***Appendix PP
Intake/Discharge
Design Modifications***

***Renewal of NPDES CA0109223
Carlsbad Desalination Project***

Re: **Technical Memorandum: Carlsbad Desalination Plant Intake/Discharge Design Modification**

Final Technical Memo: Carlsbad Desalination Plant Intake/Discharge Design Modification

Figure 3. Modified conceptual design for the New Screening/Fish-friendly Pumping Structure, plan view.

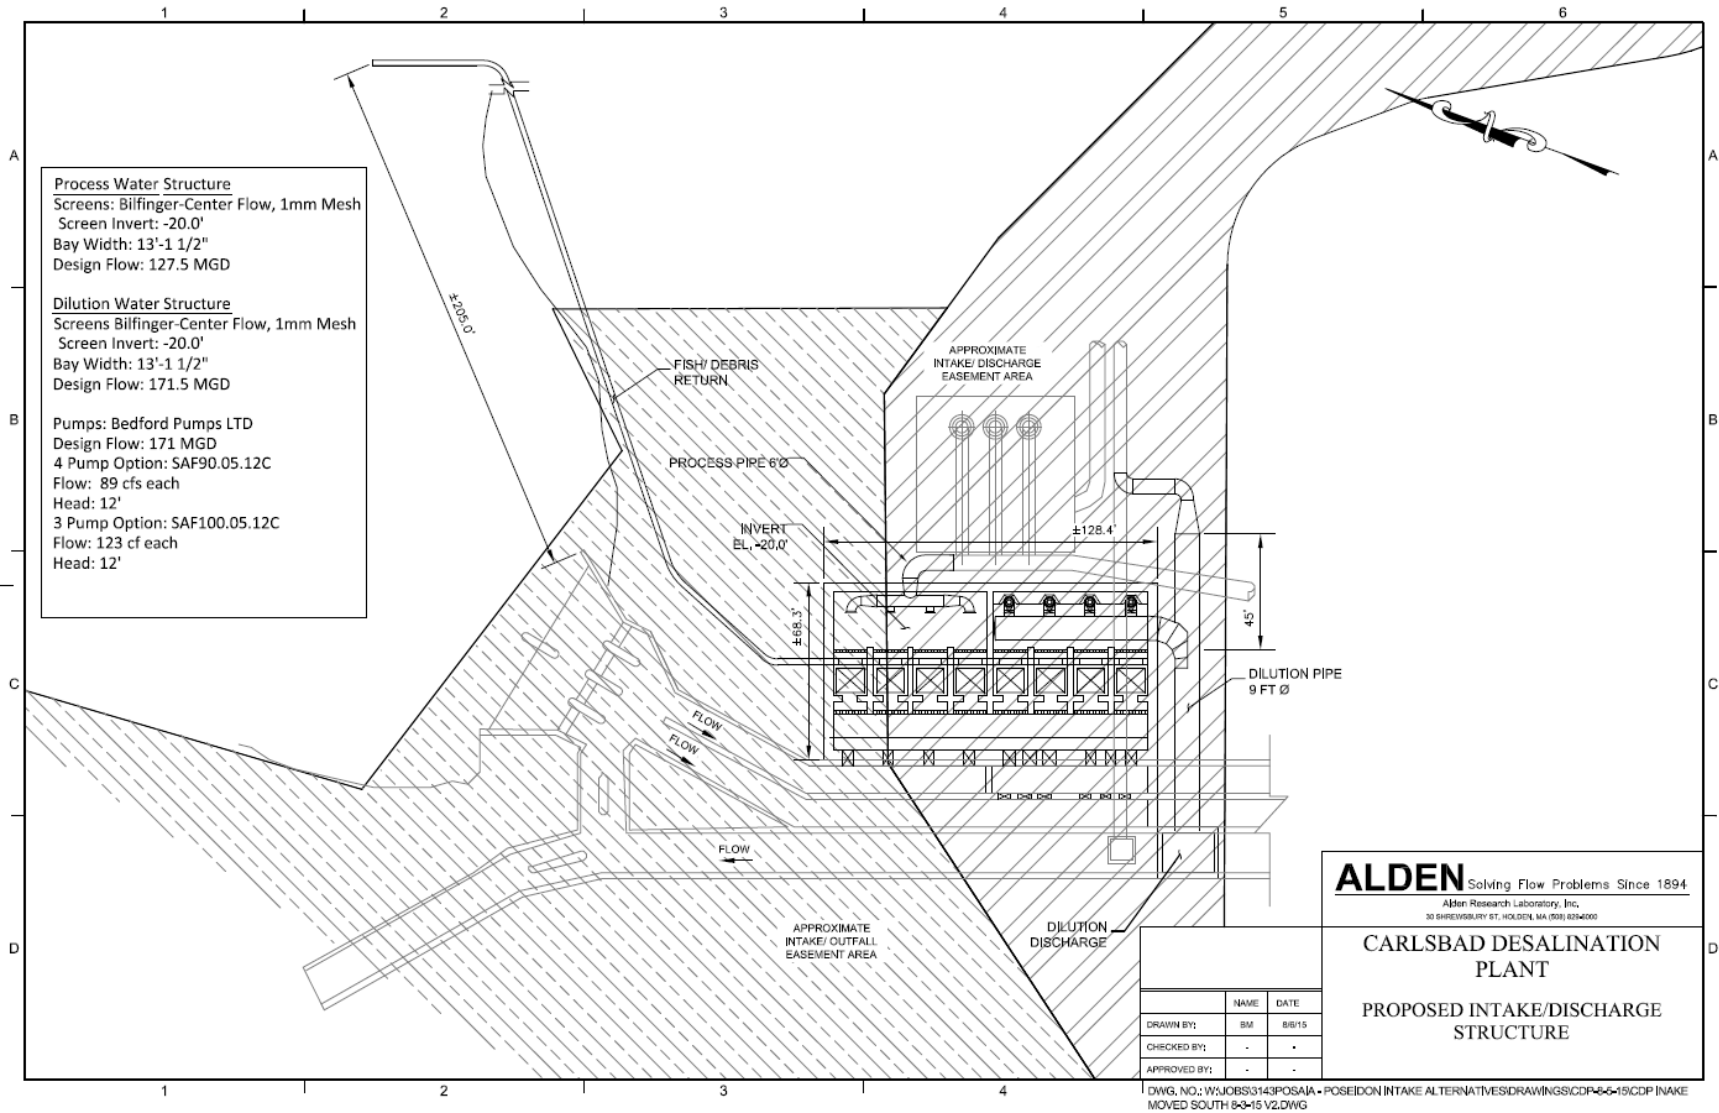
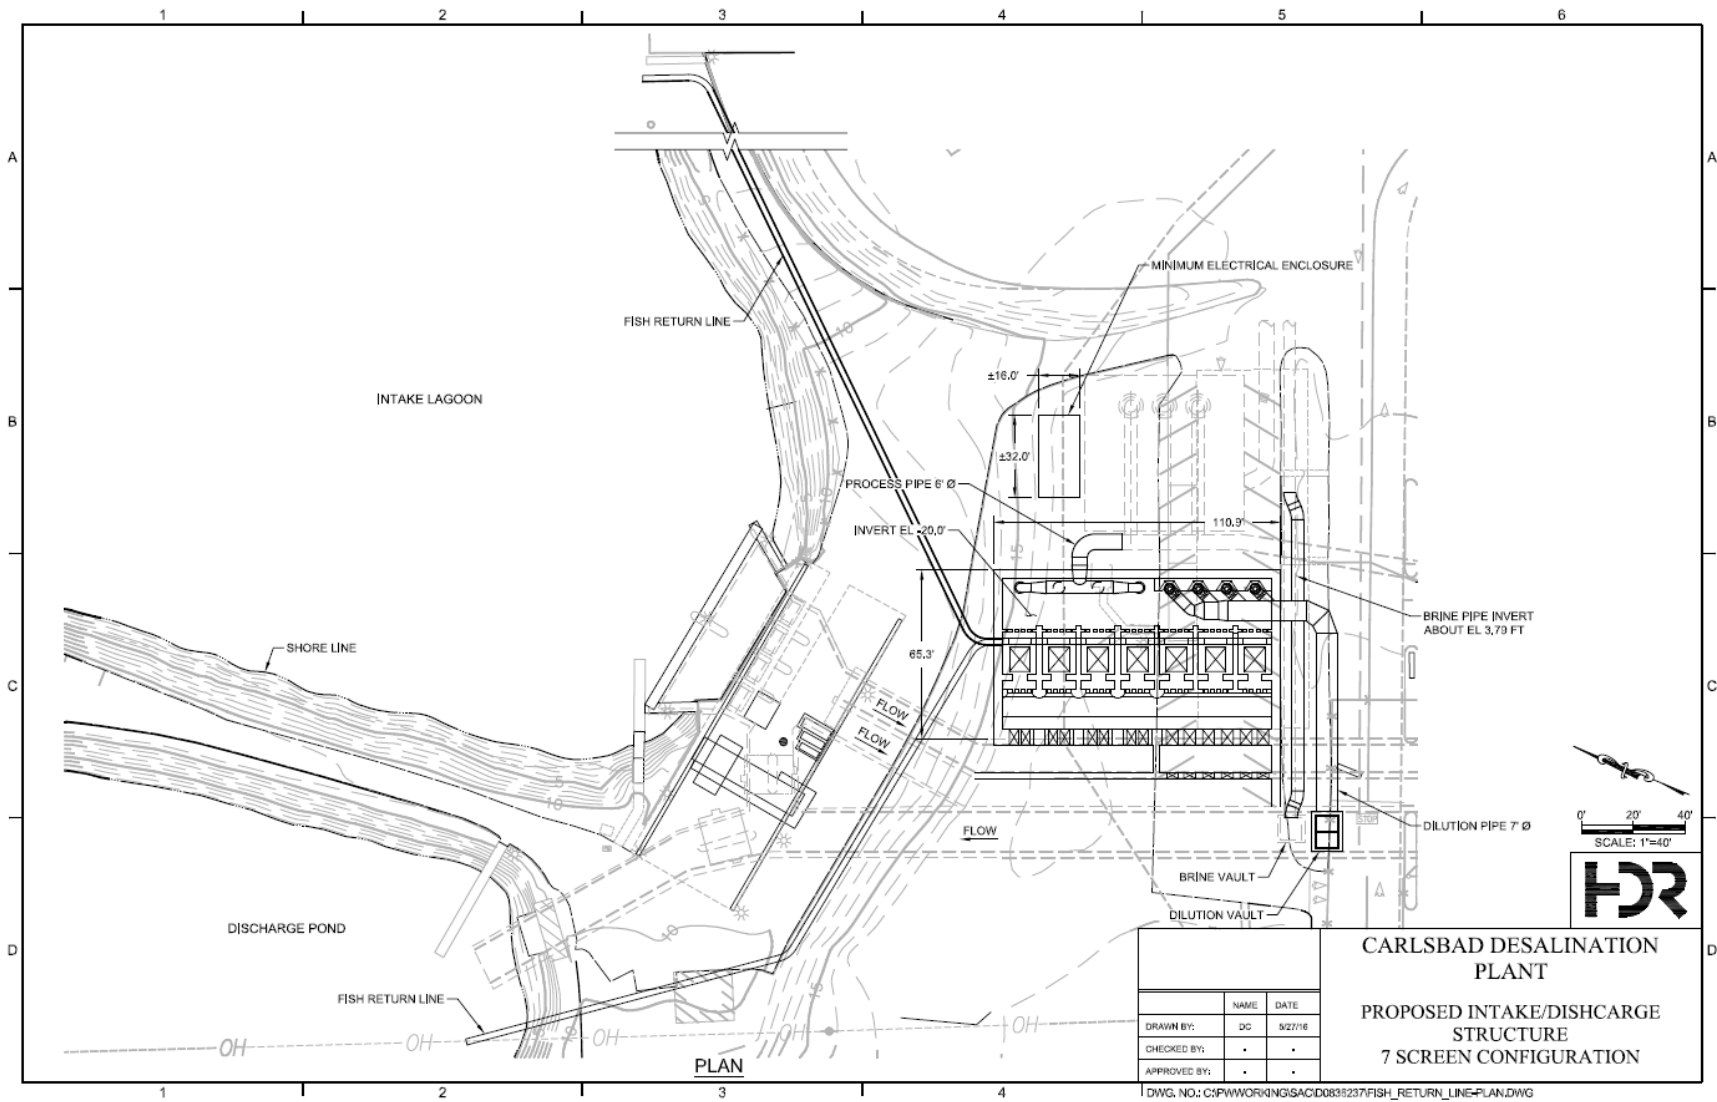
| Feature | Change | Comments |
|--|---|---|
| Ports between existing EPS tunnels and Screening/Fish-friendly Pumping Structure | Increased number of ports and changed spacing among ports | Improved flow distribution |
| Dimension from west to east | Decreased from 68.3 to 65.3 ft | Increased construction clearance around existing structures |
| Upstream T-edge of some screen bay walls | Added half rounds to T | Improved flow approaching screens |
| Traveling water screens (number) | Reduced number of screens from 8 to 7 | Decreased north-south footprint from 128.4 to 110.9 ft |
| Traveling water screens (size) | Increased width of screens from 3.0 to 3.5 m | Maintained screening area needed to keep through-screen velocity at or below 0.5 ft/sec |
| Wall downstream of screens that separates process and dilution side of the structure | Removed wall | Allowed a single redundant screen to be used for either process or dilution side of structure |
| Process manifold intake ports | Reoriented ports to point vertically down instead of horizontally forward | Increased pump bell submergence which reduces risk of vortices and may cause pump cavitation |
| Fish-friendly pump discharges | Decreased discharge piping angle from 90 to 45 degrees in flow direction | Best configuration for minimizing shear |
| Fish-friendly pump discharge manifold | Pipe diameter increased as additional flow enters manifold | Best configuration for minimizing shear |
| Combined brine/dilution pipeline | Separated two pipelines and routed each to its own vault | Improved independent hydraulic function of each by isolating each pipeline from the other |
| Brine pipeline | Portion of pipeline was offset from original alignment | Increased construction clearance around existing structures |
| Existing brine vault | Re-established connection of brine pipe to brine vault | Made use of existing infrastructure |
| Dilution vault | Added new vault for receiving dilution flow | Maintained hydraulic isolation of brine and dilution flows |
| Fish return system | Added potential alternative fish return discharge to pond | May reduce permitting and construction-related impacts |
